TOWN OF GUILFORD
ADDENDUM #4
INSTALLATION, DISPOSAL & EXCAVATION
RELATING TO WATER TANK AND WATER SYSTEM
MELISSA JONES ELEMENTARY SCHOOL
Bid #14-1011
Date: November 12, 2010

The Town Engineer, Jim Portley, has amended the vault design and therefore the scope of the bid as follows:

**SITE PLAN #2
MELISSA JONES SCHOOL
GUILFORD, CT**

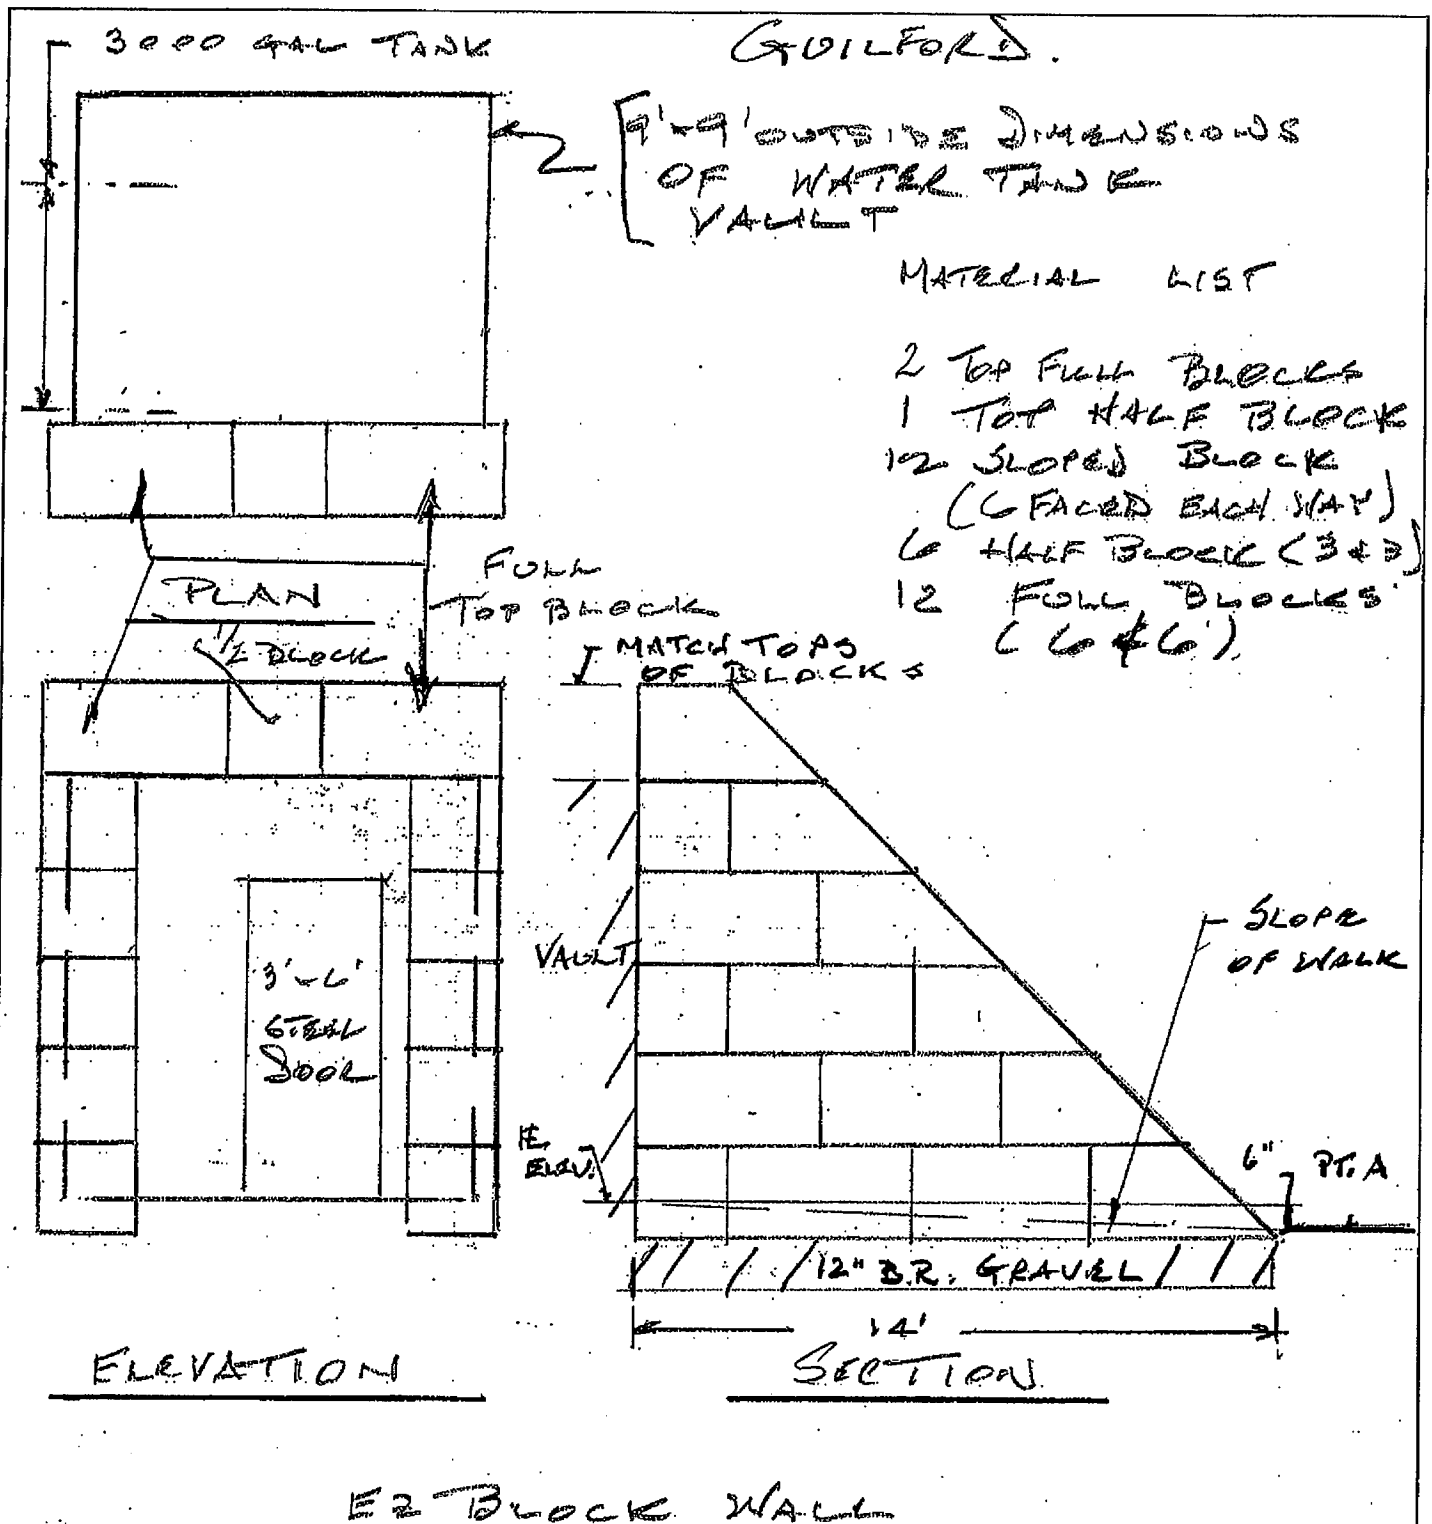
1. As a result of the site walk on 10/28/2010, the water vault structure has been re-designed. The vault will have a steel door on the east side of the street line facing the parking lot. Site Plan No. 2 (*attached*) is a 20 scale drawing that shows a 6" deep processed stone walkway from the existing asphalt sidewalk to the vault. In order to retain the embankment on both sides of the access sidewalk EZ Block retaining walls need to be set along the top of the vault and from there sloping down to the asphalt sidewalk. Enclosed is a drawing showing the plan layout, an elevation view and a section of the walls. The Town will provide the blocks and Geo Grid necessary for the installation.

2. Geo Grid fabric must be placed along the earth embankments sloped back to allow placement of the blocks and free draining material meeting the State D.O.T. specification for bank run gravel must be placed on 12" lifts between the Geo Grid material and the back of the blocks as backfill. The blocks must be set on 12" base of the bank run gravel. The top of the vault and top 6" of the sloped embankment behind the blocks must be graded to drain with topsoil. The area then must be seeded and mulched to prevent erosion.

3. The floor elevation of the vault must be set 6" above the elevation of the existing bituminous sidewalk so that the processed stone walk will slope toward the sidewalk.

4. There is an 8" diameter sump drain that is located under the bituminous sidewalk that will have to be maintained when the well pump water line and electrical wire are installed from wall No. 2.

5. The contract also includes approximately 200 ft. of utility trench from the vault to the school mechanical room for placement of electrical and pump control wiring.
